Meeting Minutes

#### Tuesday, January 9, 2024 Virtual Platform 57 East 1<sup>st</sup> Street 4:30 PM

A meeting of the Design Review Board was held at 4:30 p.m.

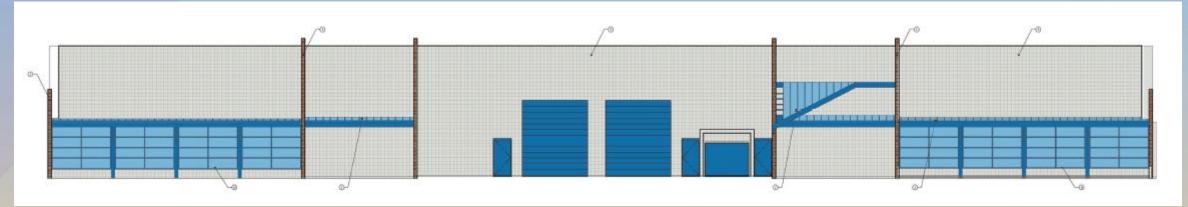
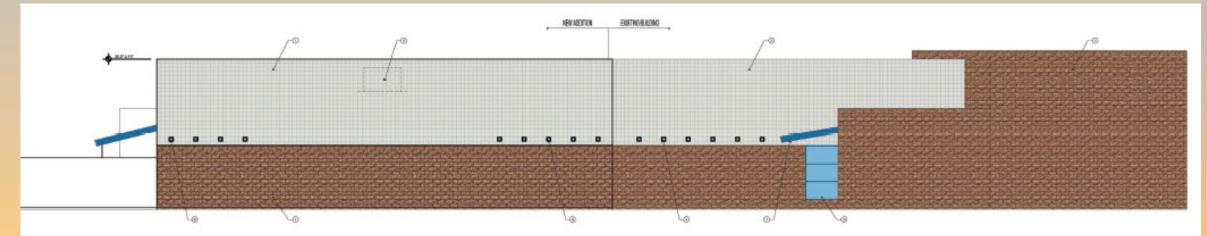
- d. Provide written notice to future property owners that the project is within 2 miles of Phoenix-Mesa Gateway Airport.
- 6. Prior to issuance of a building permit, work with city staff to provide for additional treatment for the northern elevations to be consistent with the design of the overall proposal.

### **Building A – East Elevations**

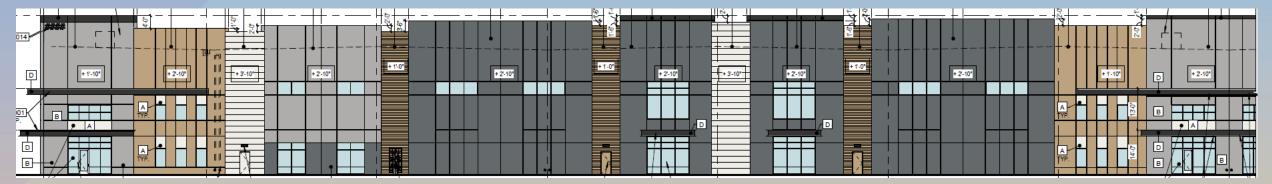
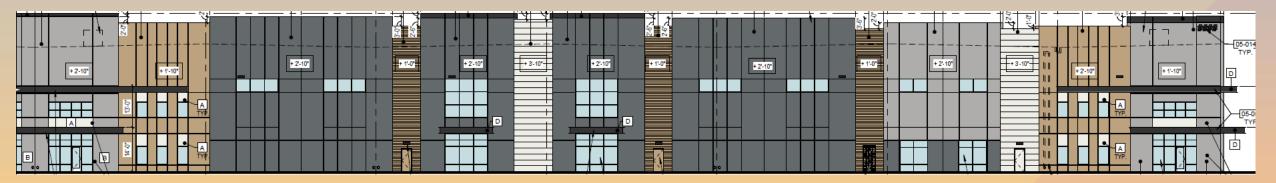
- Incorporate an element from Building A into Building B. The Board did not have a suggestion on the specific element to carry over to Building B, just something to bring more cohesion between the two buildings.
- Include an additional amenity area between Buildings A and B
- **5 Adjournment:** Vice Chair Astle moved to adjourn the meeting and was seconded by Boardmember Johnson. Without objection, the meeting was adjourned at 5:26 PM.
